Your ref
APP/20/00269

Our ref
PLAN-034260

Proposal: Construction of new coffee shop drive thru within existing car park.
Site: APP/20/00269: - Land at Asda, Larchwood Avenue, Havant, PO9 3QW.

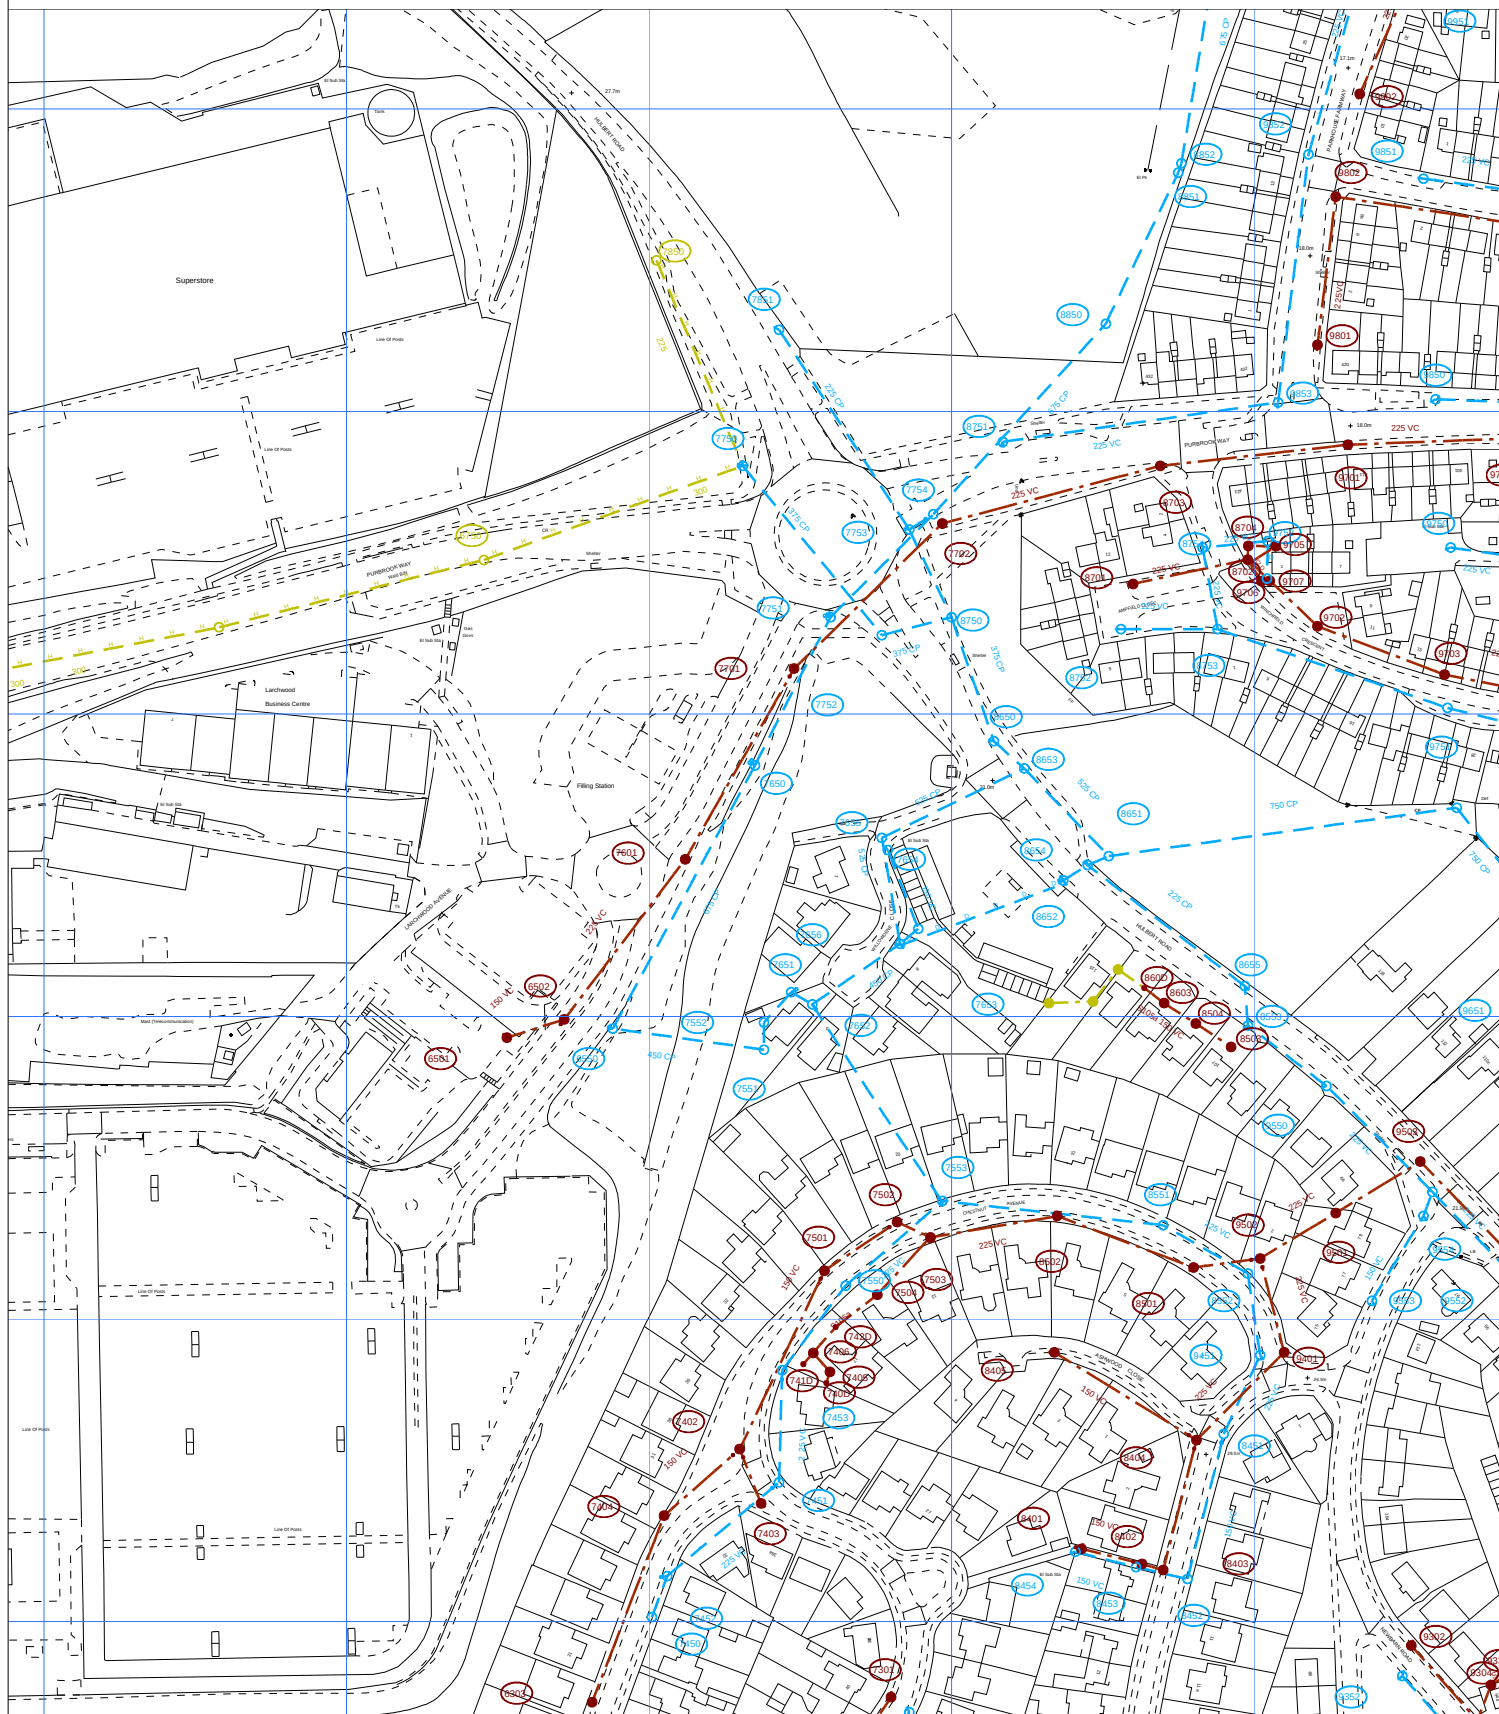
Please find attached a plan of the sewer records showing the approximate position of a public foul and surface water sewers access in the site. The exact position of the public sewers must be determined on site by the applicant before the layout of the proposed development is finalised.

- The 225mm and 650mm diameter gravity foul and surface water sewers requires a clearance of 3 and 3.5 metres on either side of the gravity sewers to protect it from construction works and to allow for future access for maintenance.
- No development or tree planting should be carried out within 3 and 3.5 metres of the external edge of the public gravity sewer without consent from Southern Water.
- No soakaways, swales, ponds, watercourses or any other surface water retaining or conveying features should be located within 5 metres of a public sewers.
- All existing infrastructure should be protected during the course of construction works.

Furthermore, it is possible that a sewer now deemed to be public could be crossing the development site. Therefore, should any sewer be found during construction works, an investigation of the sewer will be required to ascertain its ownership before any further works commence on site.
